The Commission has issued the enclosed Amendment No. 71 to Facility Operating License No. DPR-23 for the H. B. Robinson Steam Electric Plant, Unit No. 2. The amendment consists of changes to the Technical Specifications in response to your applications transmitted by letters dated April 30, 1981, April 30, 1982, and July 13, 1982, as supplemented by letters dated April 20, 1982 and June 24, 1982.

H. B. ROBINSON STEAM ELECTRIC PLANT, UNIT NO. 2

Amendment No. 71
License No. DPR-23

AMENDMENT NO. 71 TO FACILITY OPERATING LICENSE NO. DPR-23

FIGURE 3.10-1

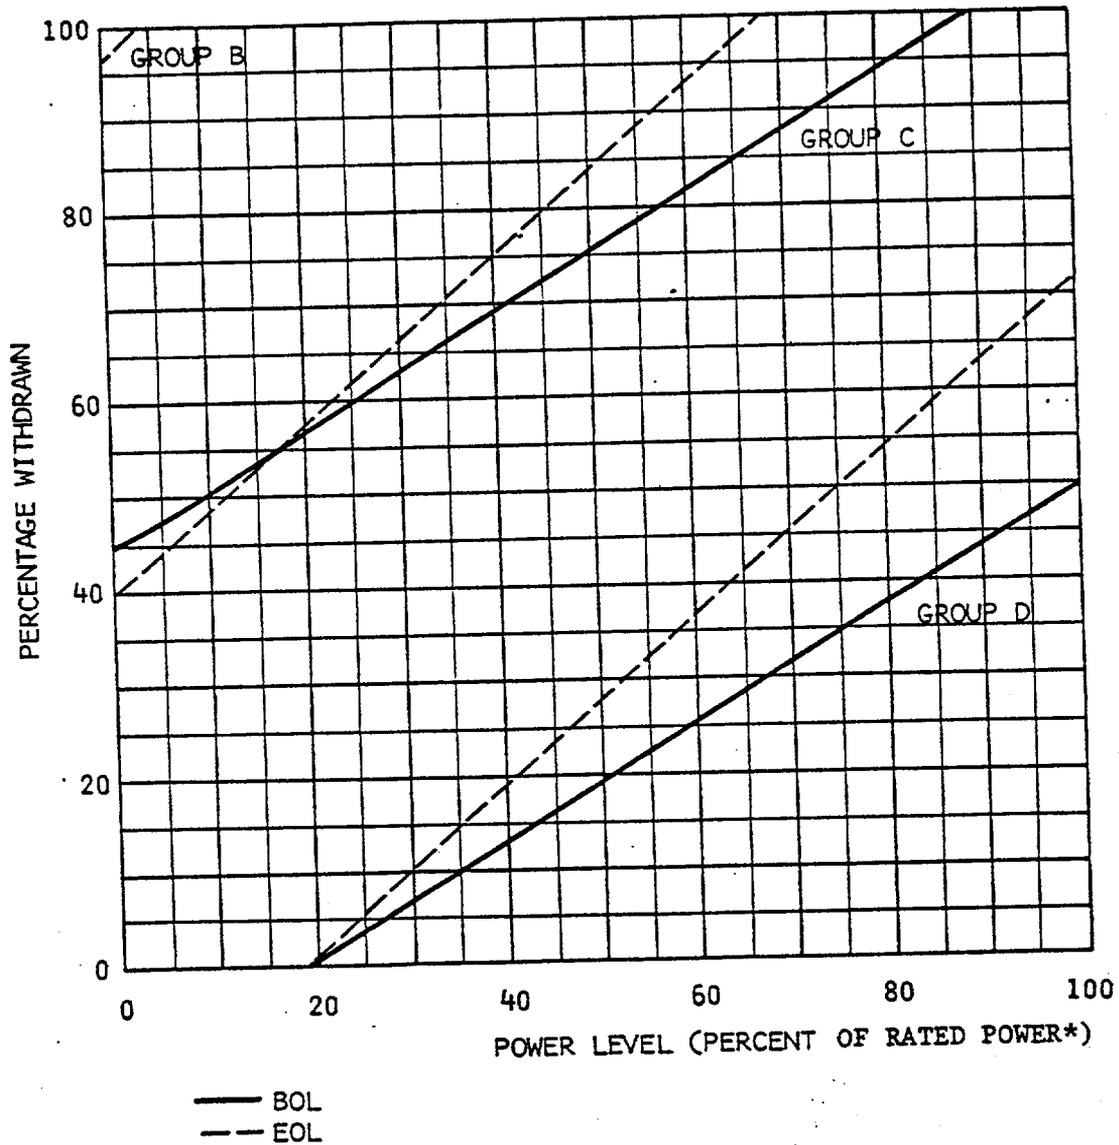
CONTROL GROUP INSERTION LIMITS FOR
THREE LOOP OPERATION

*Rated Power is defined here as 2300 Mwt under the normal T_{avg} program and 1955 Mwt under the reduced T_{avg} program.
